Pile 52 Photo

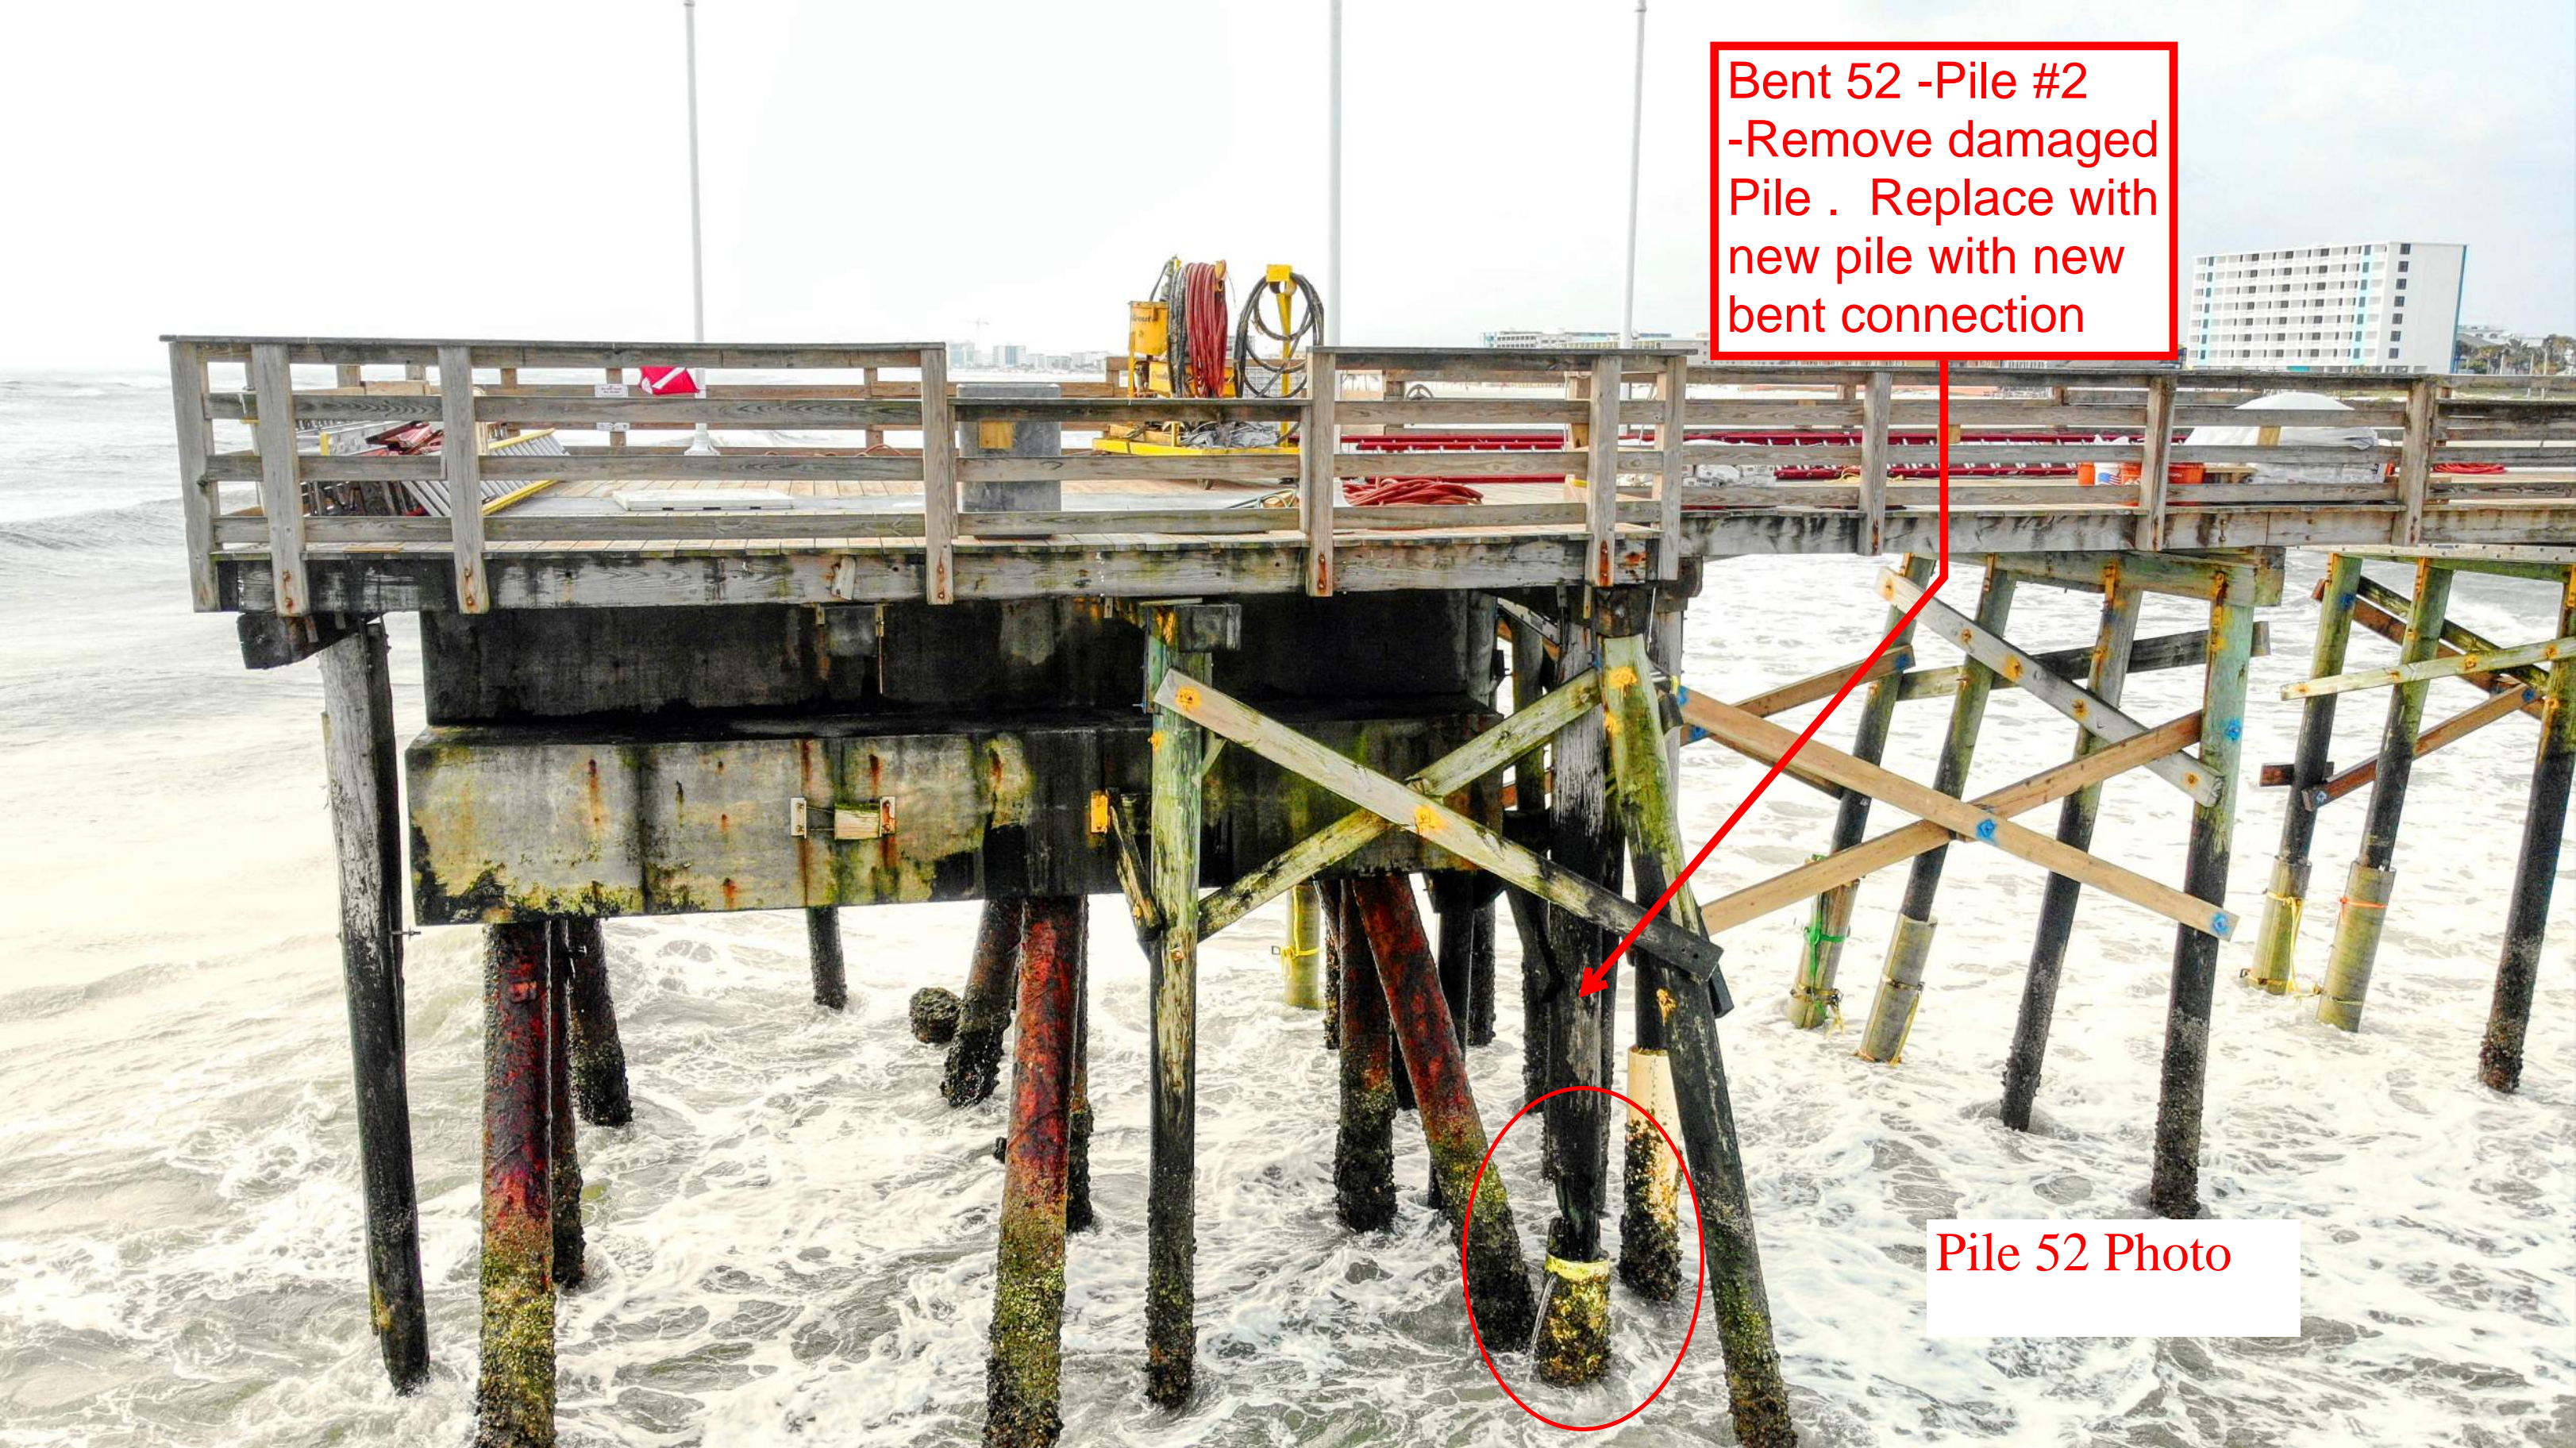
Bent 52 -Pile #2
-Remove damaged
Pile . Replace with
new pile with new
bent connection
